Plan Commission

Agenda

Monday, January 25, 2016	7:00 PM	De Pere City Hall Council Chambers
---------------------------------	----------------	---

Item 3: Review and Recommendation on the Site Plan Application for 730 and 746 Main Ave for a Motor Vehicle Service Station. Applicant: Kwik Trip

C2.11

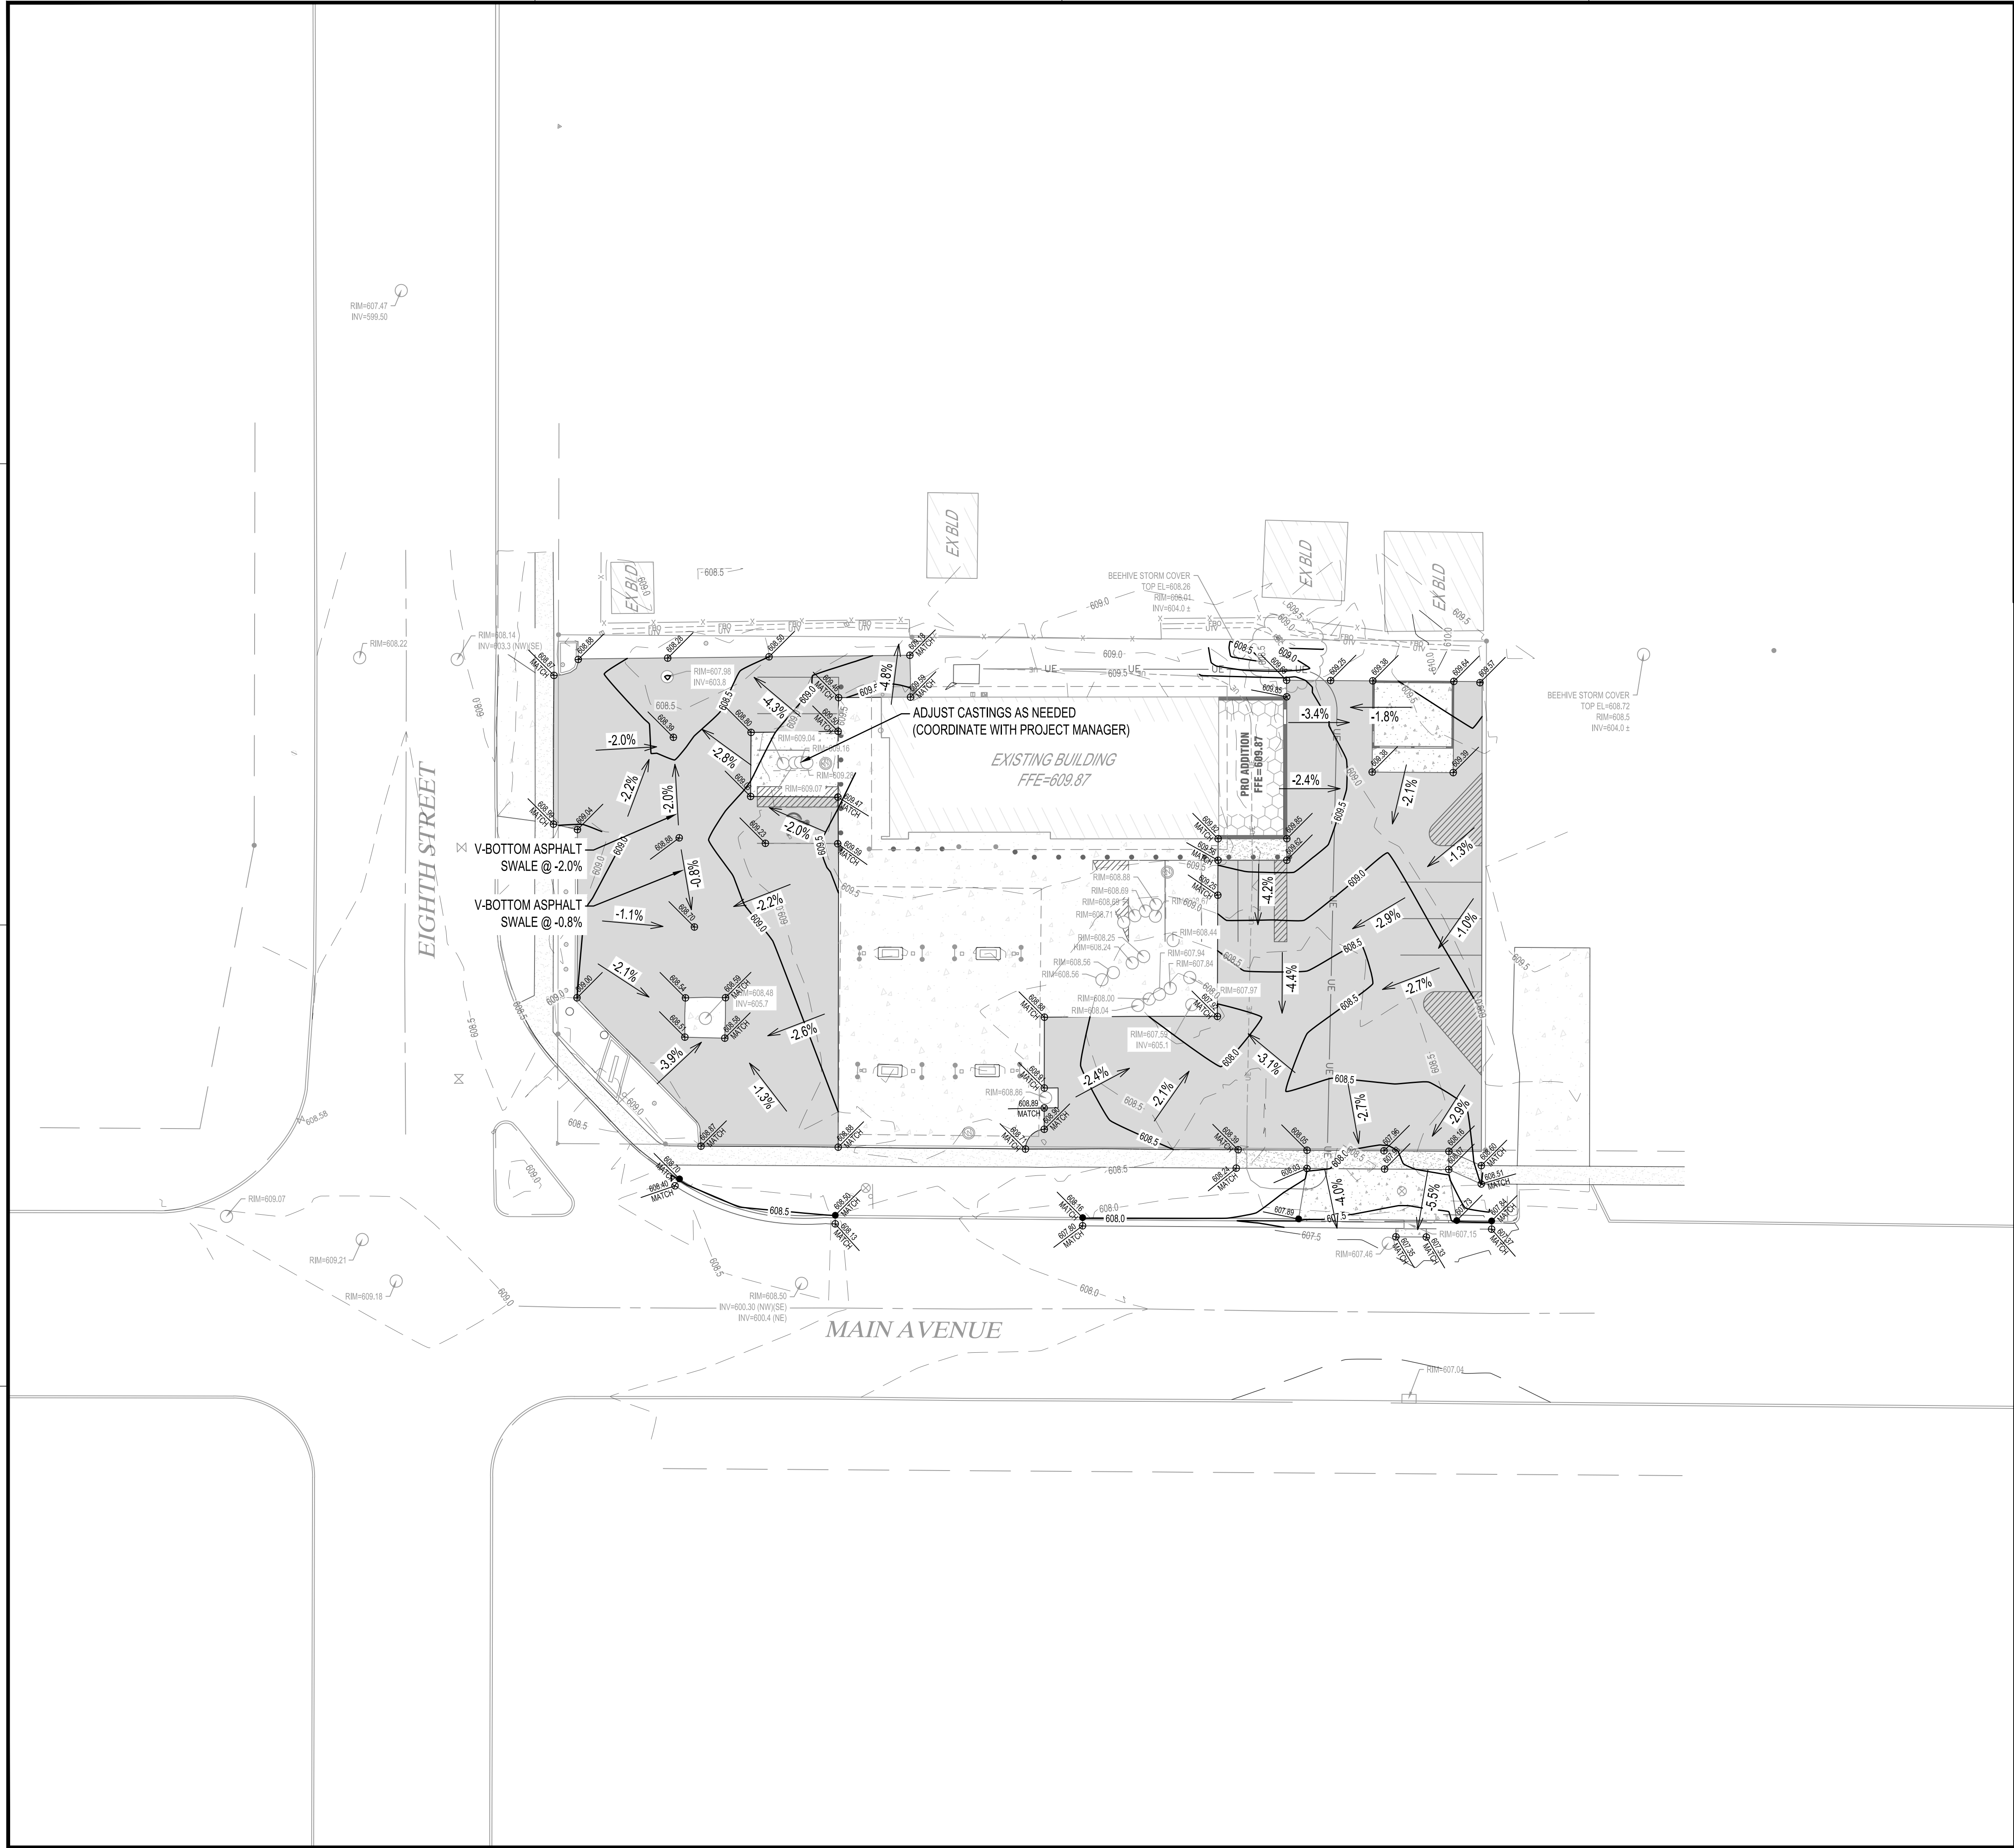
1. Show the sanitary sewer lateral on the plan.
2. The plan shows two water service connections/existing curb stops. One will need to be abandoned. Clarify on the plan the existing size of the water service that will remain and label the one that will be abandoned.

7. An existing 12-inch storm sewer pipe runs along the north property line. Provide a 10 foot easement for the City to maintain this pipe.
8. Show the storm drain connections to City storm sewer on the plan.

11. No new utility connections are shown on the plan, provide if applicable.
12. Show and label the right of way and property lines on the plan.
13. Show dimensions of adjacent streets and right of ways.

14. Curb cut permits are required for new driveways.
15. The plan specifies 14 new parking stalls required and 20 stalls provided. The count on the plan shows 12 stalls provided. Please identify the location for all 20 parking stalls to be provided.

16. Show the lighting photometrics behind the building on the plan.
17. The address on the site plan is listed as 740 Main Avenue. Our records show the site as 746 and 730 Main with 746 as the address for the current business. Please update address on the site plans.

1. Signage - shall be in accordance with Chapter 98.
2. Parking – Please provide parking details within the Site Plan. The plans submitted do not call out specifically all the parking locations.
